Thoughts on the IL strawman

G. Zimmerman 1/18/2021

CME Consulting

sedarat_3cy_01_01_05_21.pdf slide 9

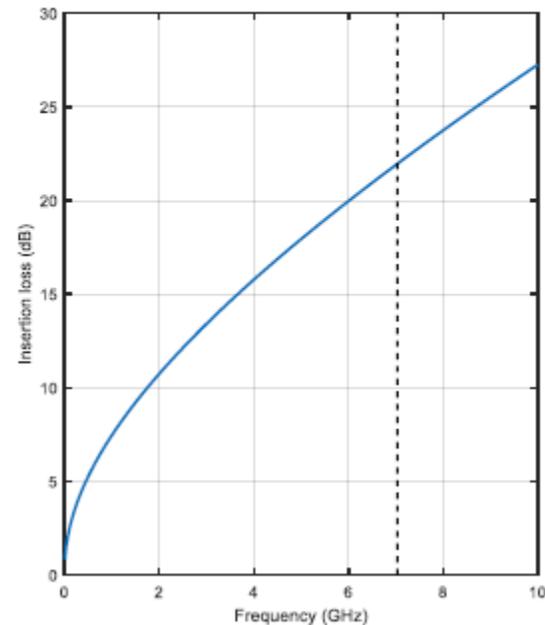
Is Sedarat_3cy_01_01_05_21 margin on top of margin?

- Some issues mentioned in slide 8:
 - PCB loss/materials
 - Loss for connectors
 - Minimum tx power
 - Implementation loss
 - Should this include crosstalk noise?
 - FEC coding gain? (computed directly)
 - Is 5 dB reasonable or overkill?
- Additional issues discussed in TF:
 - Temperature of full cable of 105C vs lower avg. temp not relevant to IL limit line, only to evaluation of cables
- Further potential:
 - -140 dBm/Hz was a PHY complexity trade off, not a hard limit. 3 dB could be had here
 - What margin is considered reasonable in the end? – depends on budgets included
 - Analysis of EMI margin directly

802.3ch Receiver Alien Crosstalk test noise (149.5.3)

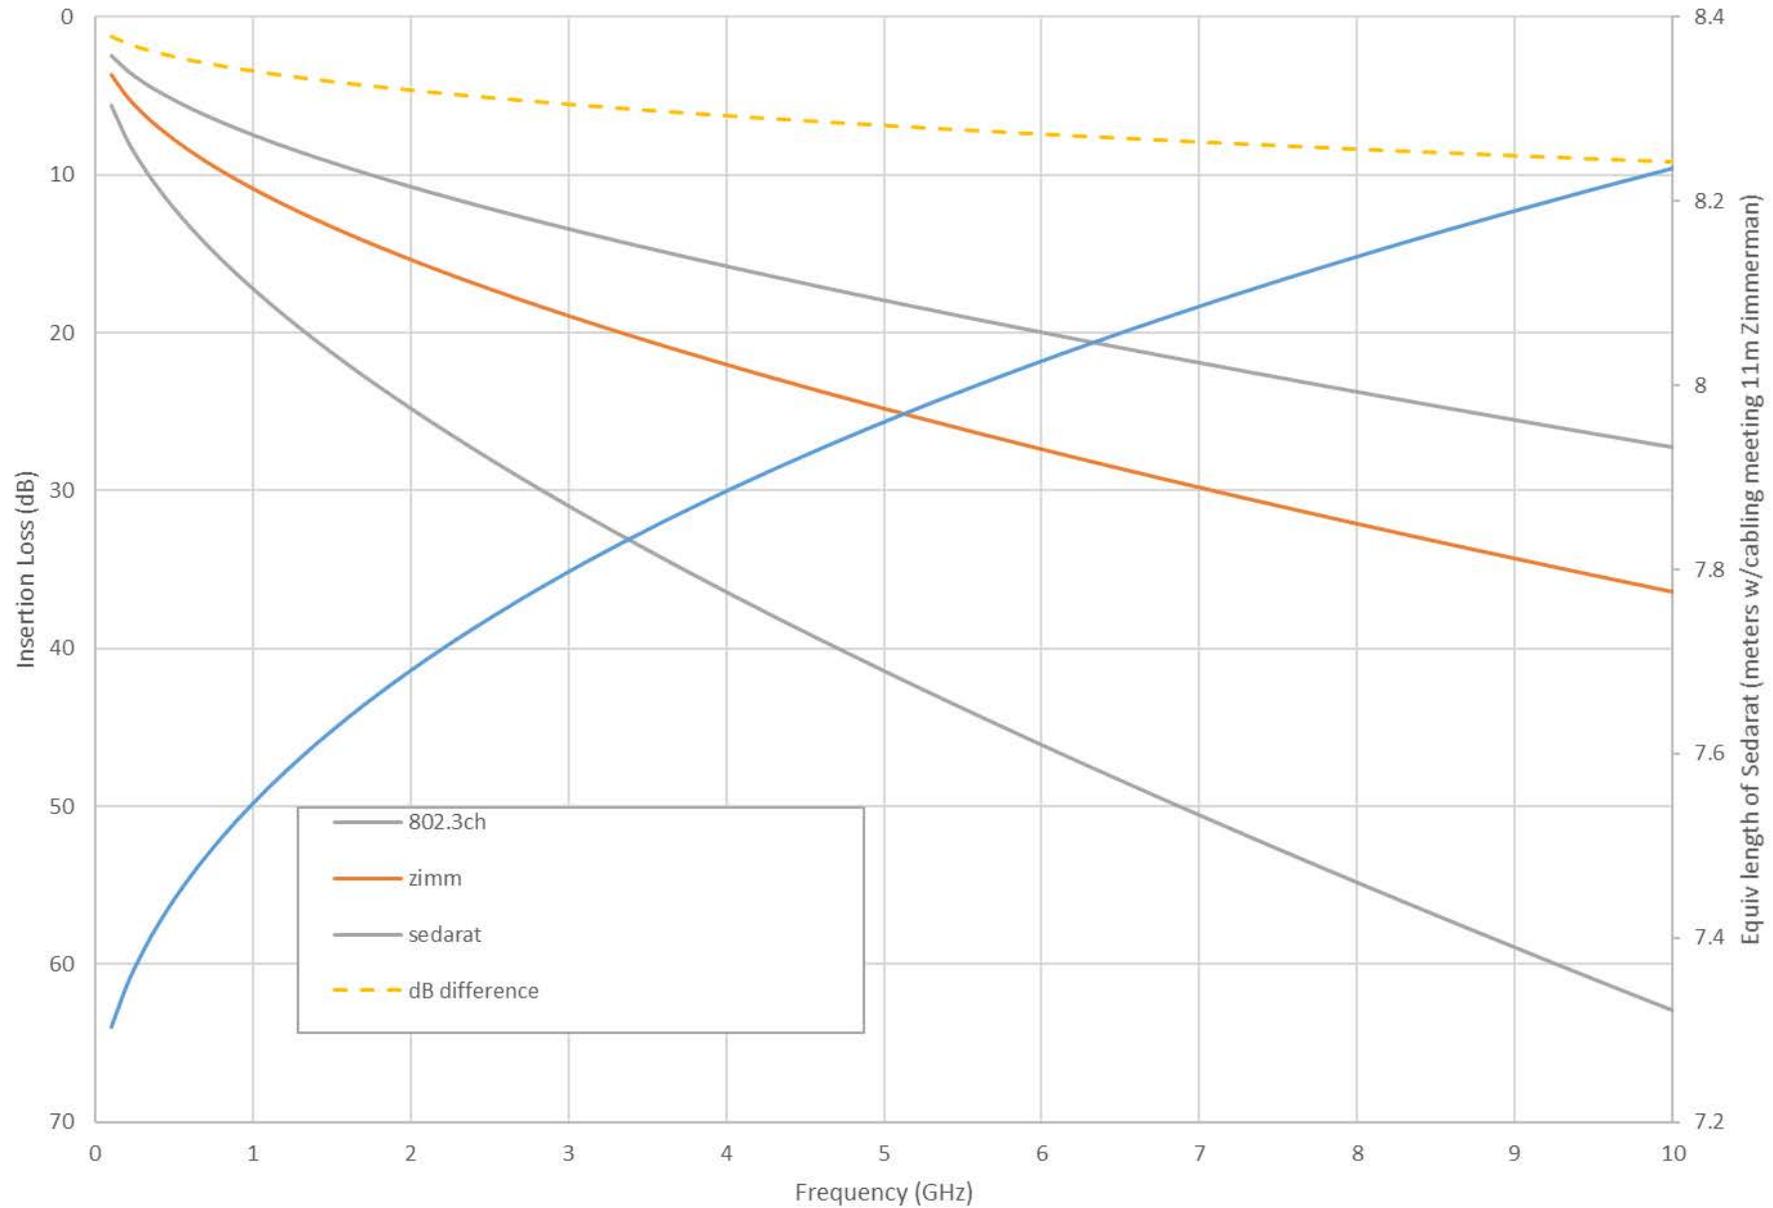
- 802.3ch alien crosstalk level of -152 dBm/Hz over 3.5 GHz
 - -56.56 dBm rms noise (2.2 nW)
 - 0.47 mVrms into 100 ohms
- $1e-12$ (~7-sigma) -> 3.3 mW

- Alien crosstalk is at similar levels to 802.3ch, -152 dBm/Hz crosstalk adds only 0.3 dB loss (NOT necessarily additive in dB to losses)
- RX noise impulse events mask EMI impulse events 5.7x larger than

A possible path to 11m, single cable

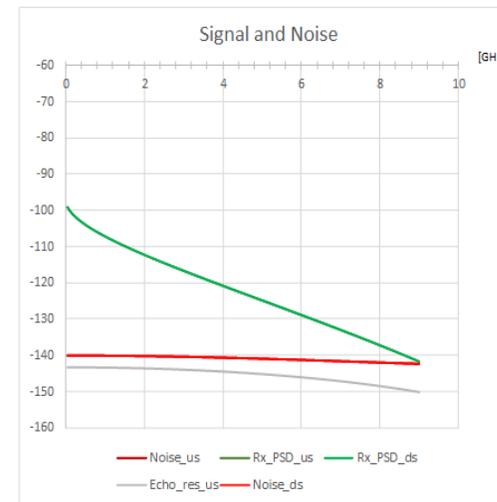
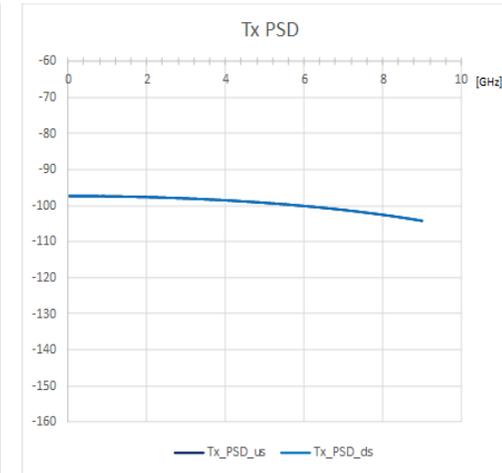
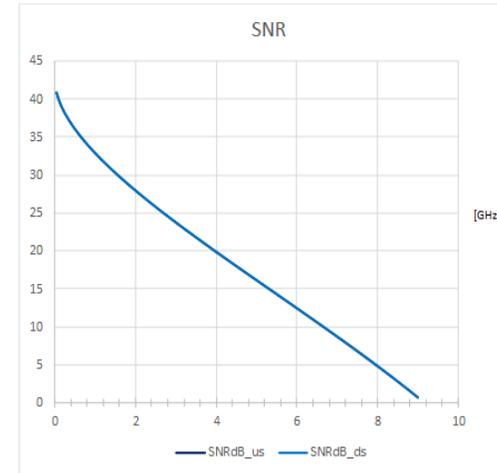
- Start with Mueller SDP cable
 - Mueller_3cy_01_12_01_20.pdf
 - PCB losses modeled
- Improve PHY front end noise 3 dB
 - To -143 dBm/Hz
 - ZOH modeled
- Reduce average temperature to 95C
 - Per Wienckowski profiles
- Maintain 5 dB budget for all implementations
 - (we've lowered the front-end noise)
- Positive margin
 - Still room for improvement on both PHY and cabling

Insertion Loss Limit Lines

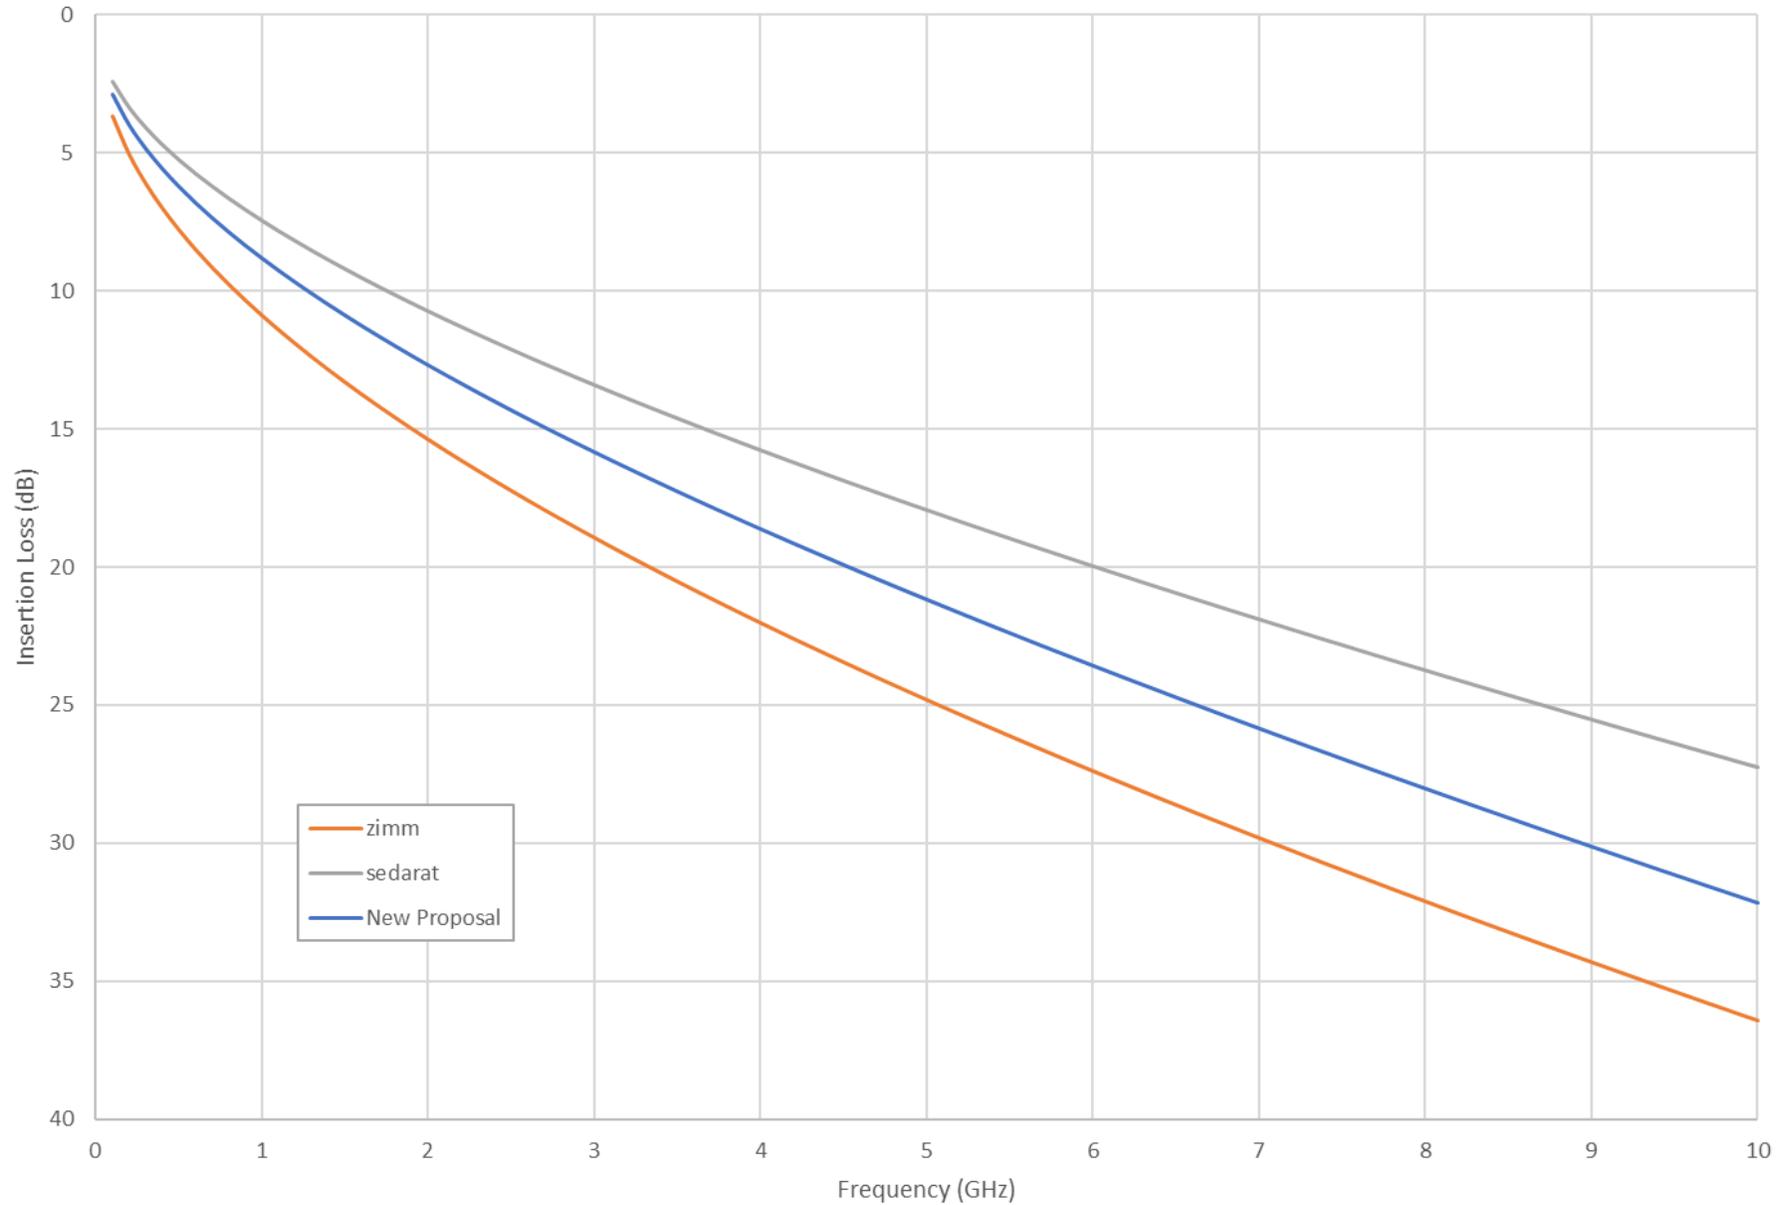
dB IL at 7 GHz	Insertion Loss (dB) vs. freq (MHz)
802.3ch	29.80	$\leq 0.002 f + 0.68 f^{0.45}$
Nov. Strawman (zimmerman):	29.80	$\leq 0.002 (f/2.5) + 0.68 (f/2.5)^{0.45}$
Jan 12 Proposal (sedarat):	21.90	$\leq (6.5/15) \times (0.002 f + 0.68 f^{0.45})$
New Strawman proposal	25.85	$\leq 1.180 \times (6.5/15) \times (0.002 f + 0.68 f^{0.45})$ $= 0.00102 f + 0.348 f^{0.45}$
Mueller_3cy_01_12_01_20 SDP cable @ 95C	26.7 dB	(relaxation from 105C from wienowski, based on model in Jonsson spreadsheet)

- We are NOT ready to adopt baseline
- Economic feasibility demands balancing the relative cost factors between components
- PHY must share the pain – but cannot take all of it
 - Consider both receiver parameters, implementation, and operating margin
 - different vendors will divide these differently
- Recommend establishing a new strawman IL as our target, at least “splitting the difference” between cabling and PHYs
 - Not a baseline, still a strawman
